Access Compliance Report Public Rights-of-Way (Curb Ramps)

Main Street: ROSSMOOR_WAY Cross Street: LOS_ALAMITOS_BLVD Location: NW

ADA ID: RPRK211217124404 Ramp Type: Type 1 - Perpendicular Diagonal Initial Pass/Fail: Pass Overall Compliance: No Severity Score: 6

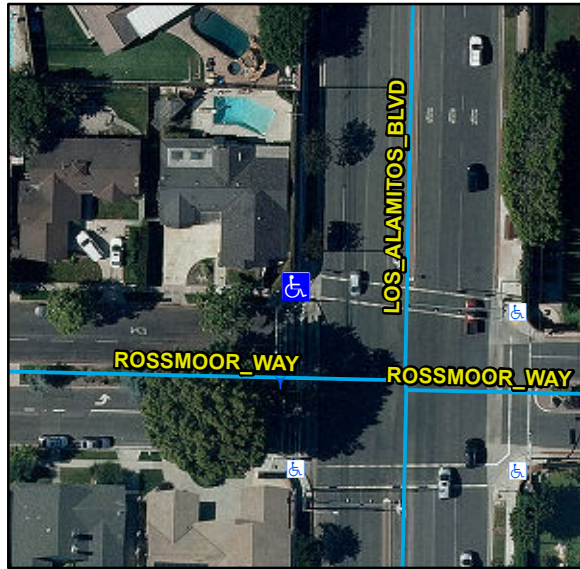
Compliance	Description	Data	Compliance	Description	Data
N/A	Ramp Length (in)	67	N/A	Flare Type LT	
Yes	Ramp Width (in)	48			Sloped
Yes	Ramp Run Slope (%)	6.2	Yes	Flare Slope LT (%)	9
Yes	Ramp Cross Slope (%)	2	N/A	Flare Traversable LT	Yes
N/A	Landing Present	Yes	N/A	Flare Type RT	
N/A	Landing Length (in)	40			Sloped
Yes	Landing Width (in)	48	Yes	Flare Slope RT (%)	7.3
Yes	Landing Run Slope (%)	0.6	N/A	Flare Traversable RT	Yes
Yes	Landing Cross Slope (%)	0	Yes	DWS Provided	Yes
N/A	Landing Movement Obstructed?	No	Yes	DWS Contrast	Yes
	Landing Movement Type	N/A	Yes	DWS Length (in)	36
N/A	Landing Shared	No	Yes	DWS Full Width	Yes
Yes	Clear Space	Yes	Yes	DWS Offset Left (in)	0
Yes	Clear Space To Crosswalk (in)	48	Yes	DWS Offset Right (in)	N/A
N/A	Marked Crosswalk 1	Yes	N/A	Marked Crosswalk 2	Yes
	Crossing 1 Direction	S		Crossing 2 Direction	E
	Marked Crosswalk 1 Width (in)	144		Marked Crosswalk 2 Width (in)	144

Remove & Replace Landing.

R304.2.1, STD 1115
